**Development of Bristol Airport to Accommodate 12 Million Passengers Per  
Annum: Response to Comments from North Somerset Council on Biodiversity**

This note has been prepared in response to comments provided by the North Somerset Council (NSC) Biodiversity Officer on the planning application and supporting Environmental Statement (ES) for the proposed development of Bristol Airport to accommodate 12 million passengers per annum (mppa) (Application No. 18/P/5118/OUT). Specifically, the note responds to comments received in respect of the biodiversity impacts of the proposed development.

North Somerset Council: Formal Comments from Sarah Dale, Temporary Natural Environment Officer – 24/01/18 and by email 14/02/19	
Theme/Subheading	Extract from document and BAL response
Summary: Designated Sites  <i>Please refer to detailed response below.</i>	It has been ascertained that NOx emissions, nitrogen deposition and acidity will exceed critical loads or targets for several designated sites, but that the levels of this are not considered to be significant. I will need to seek further advice from colleagues in the air quality team and their supporting consultants regarding this issue. Th

Figure 3 Aircraft flight tracks and AGL ft for departures (Bristol Channel is visible to the west and Chew Valley and Blagdon Lakes to the southeast).

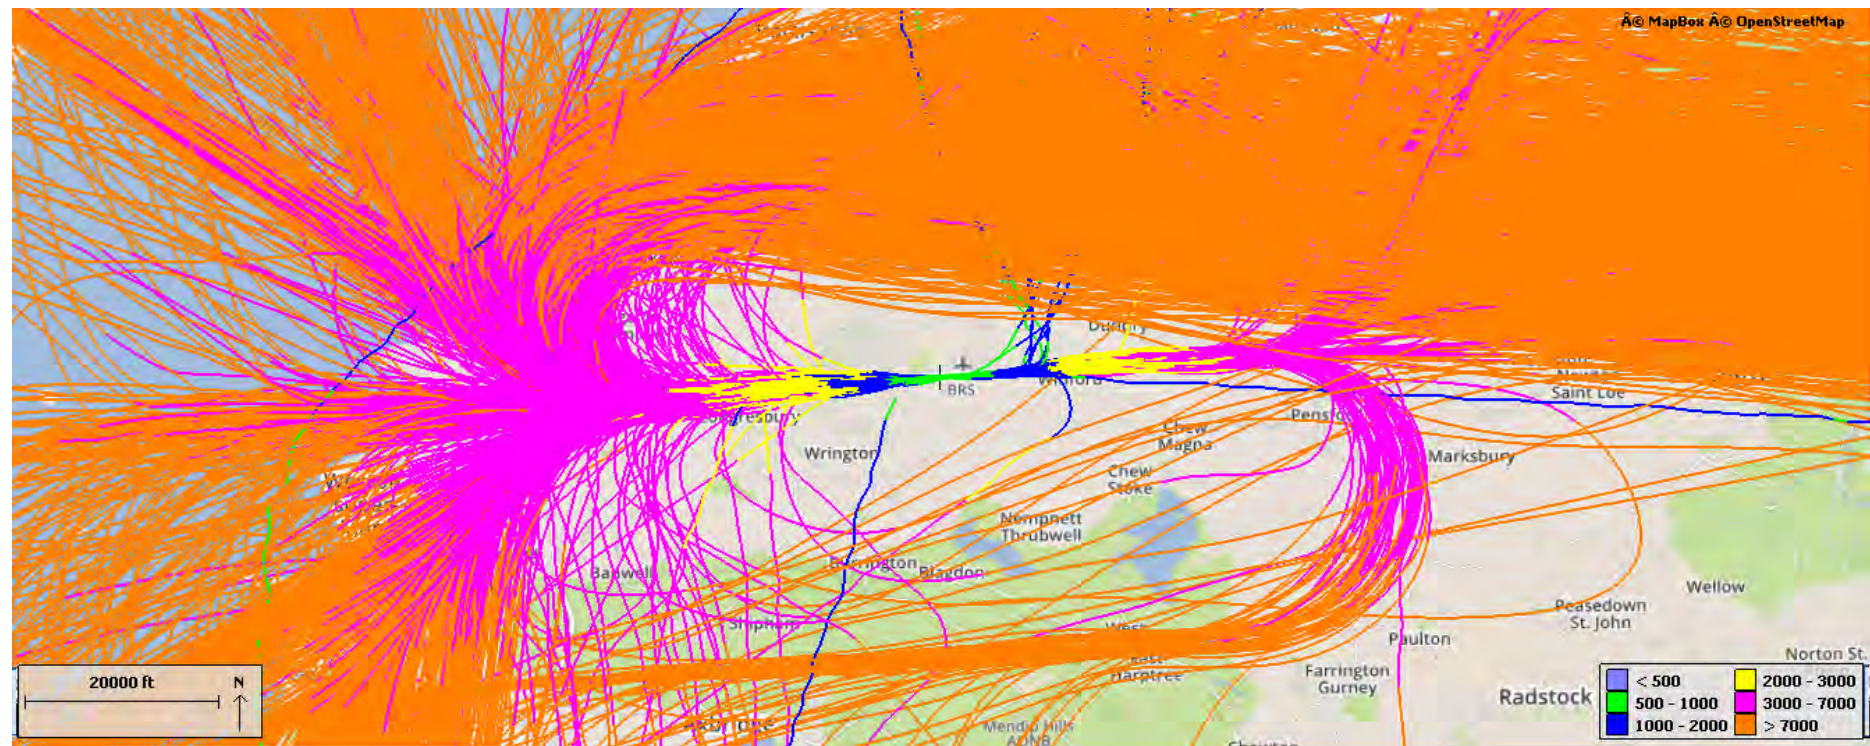
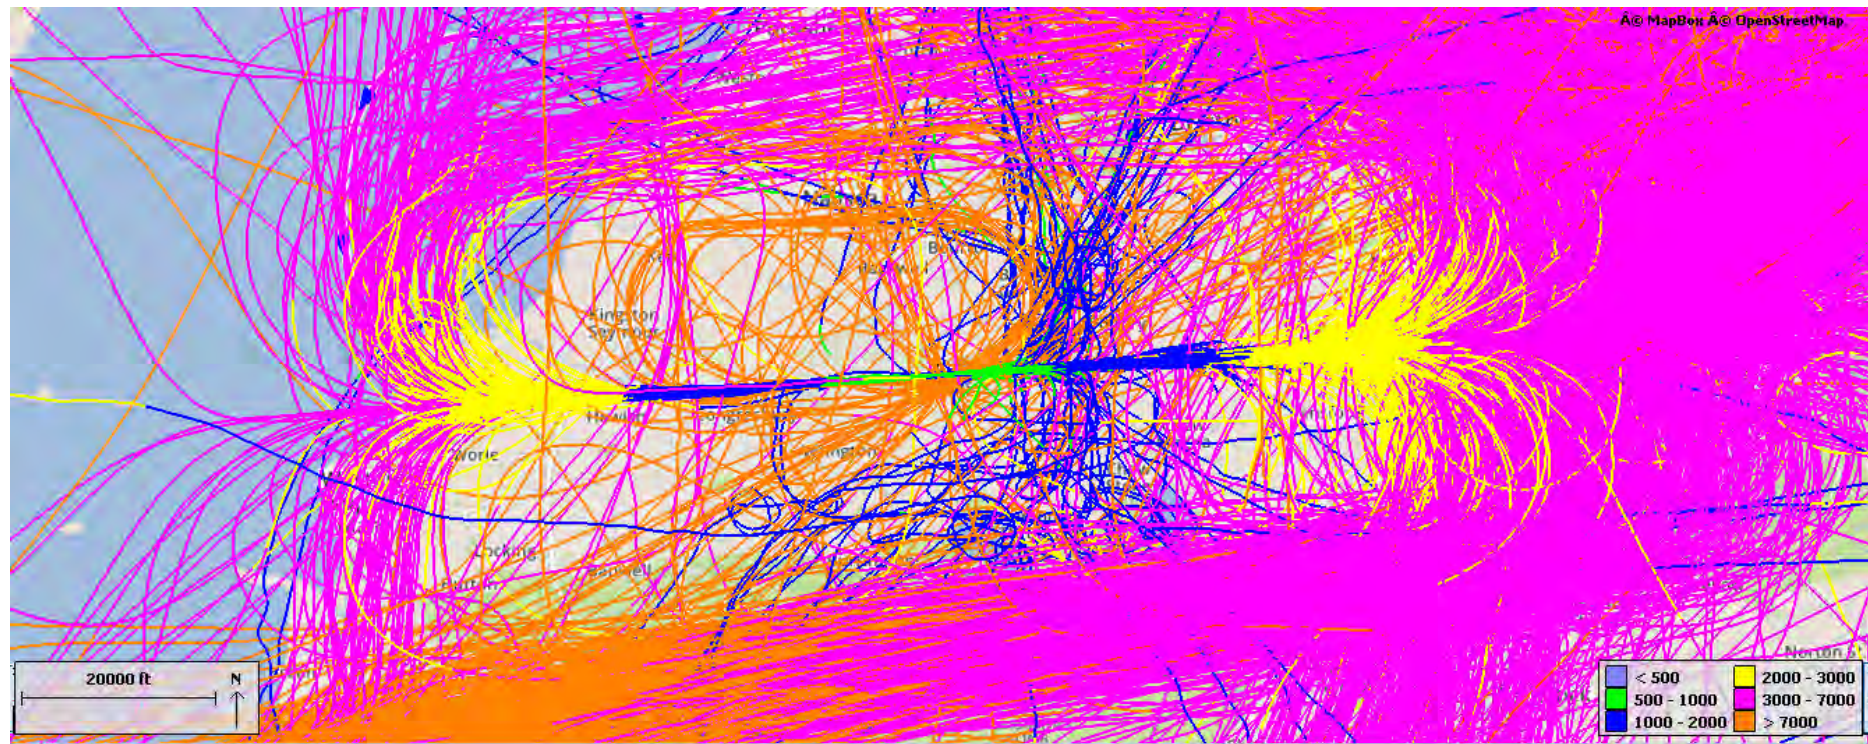
<b>Other Designated Sites</b>	
<b>Further information 4</b>	<i>"I am satisfied that impacts on wetland birds including disturbance can be scoped out of the ES. I would also not consider that a Habitats Regulations Assessment (Test of Likely Significant Effect) needs to be provided, although this is subject to agreement with Natural England"</i>
<p>Natural England has not raised this as being of further concern in its written response to North Somerset Council dated 25<sup>th</sup> January 2019 reference 268908.</p> <p>BAL has contacted Natural England (Amanda Grundy) and a site visit and meeting with Amanda Grundy, together with a bat specialist and SSSI specialist has been arranged for 04/04/19 to discuss/agree any final concerns/advice through its Discretionary Advisory Service.</p> <p>BAL has also conducted further research and review of its track keeping data and this information is provided below with respect to statutorily designated sites associated with wetland birds. This information demonstrates that no flights below 1000ft (which are those perceived to have the greatest potential to cause short term disturbance) have been recorded within the sample data (August 2017 – one of the business periods of flying). The following figures illustrate the location of key statutory designated sites associated with birds for reference against flight track data, that includes those designated/notified for bird interest (Figures 1 and 2) and flight tracks/Above Ground Level (AGL ft) for arrivals in August 2017 (Figure 3) and departures in August 2017 (Figure 4). NB SPA is used as a surrogate for the location of related Ramsar Sites)</p>

Departures: No flights under 1,000ft over these or other statutorily designated sites.

Arrivals: No arrivals below 1,000ft at these or other statutorily designated sites.

This additional data further supports the conclusion that impacts on wetland birds including disturbance can be scoped out of the ES and that a HRA (Test of Likely Significant Effect) does not need to be provided.

Figure 6. Flight tracks and AGL ft for aircraft departures over the SAC

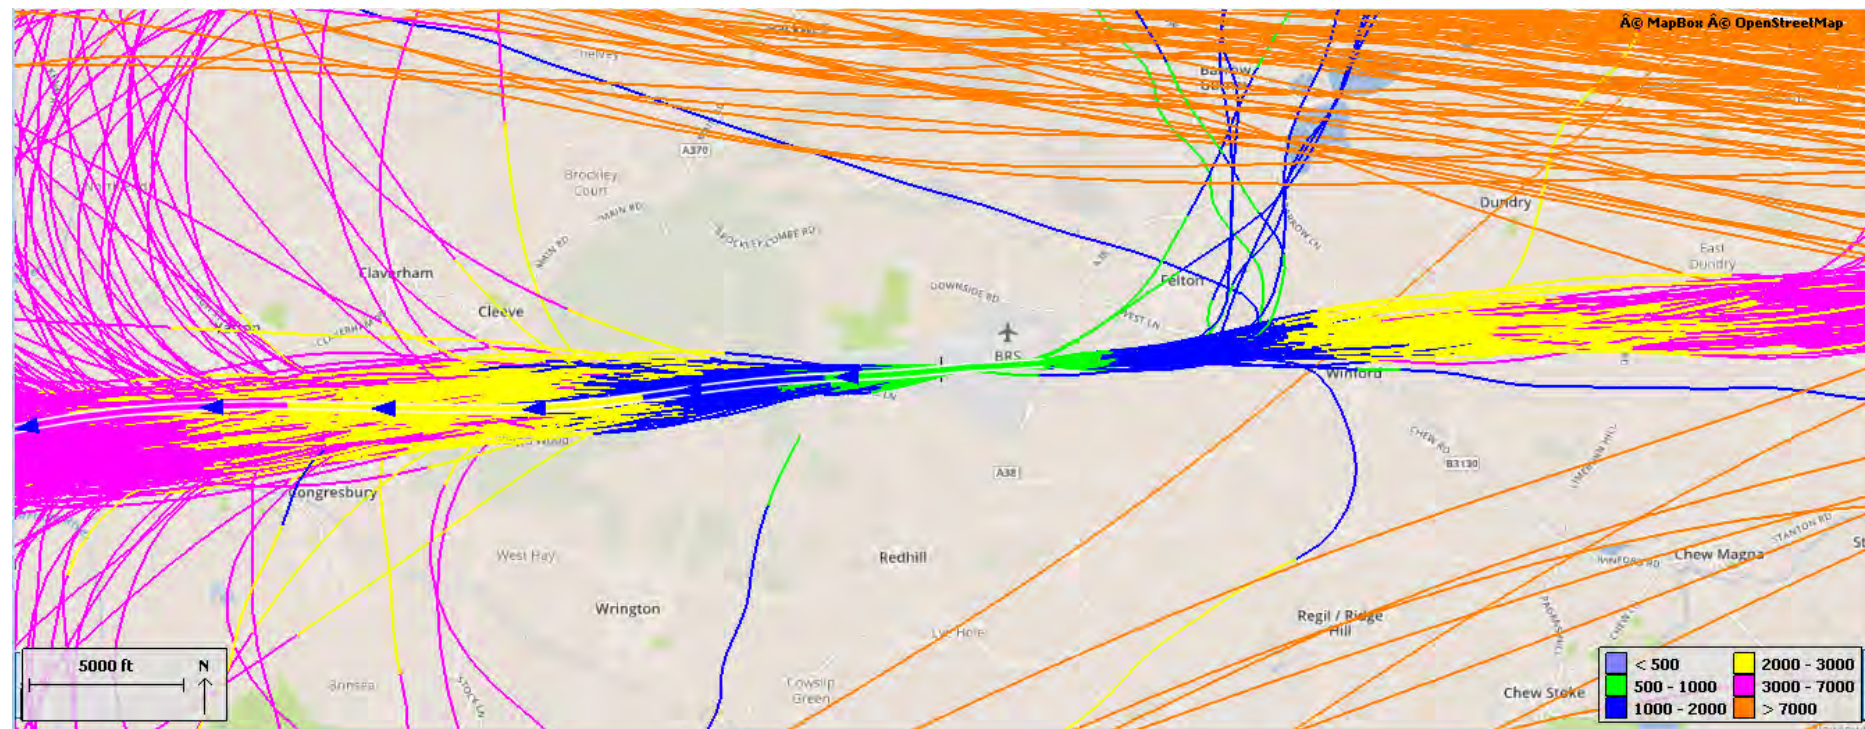
BAL has conducted further research/review of its aircraft flight tracking data, using August 2017 as a case study (a busy period and sensitive in terms of bat activity). This is shown overleaf. Figure 5 shows the location of the North Somerset and Mendips Bat SAC close to Bristol Airport. Figure 6 shows flight track data on departures from August 2017 (the busiest period) and Figure 7 shows flight track data for arrivals from August 2017.

Departures – It is very unlikely that aircraft would be 1,000ft or below when reaching the ‘North Somerset and Mendips’ SAC on 27 departures as illustrated by the tracks presented above.

The flight tracks demonstrate the relative heights of aircraft above the SAC on approach and departure are almost always in excess of 1000ft above the SAC (e.g. Kings Wood). Considering horseshoe bats roost within buildings, caves, mines and other noise insulated structures, it is reasonable to conclude that any increase in night flights during the summer will not cause any notable magnitude of change in noise conditions experienced by bats and associated effects on the favourable status of the population.
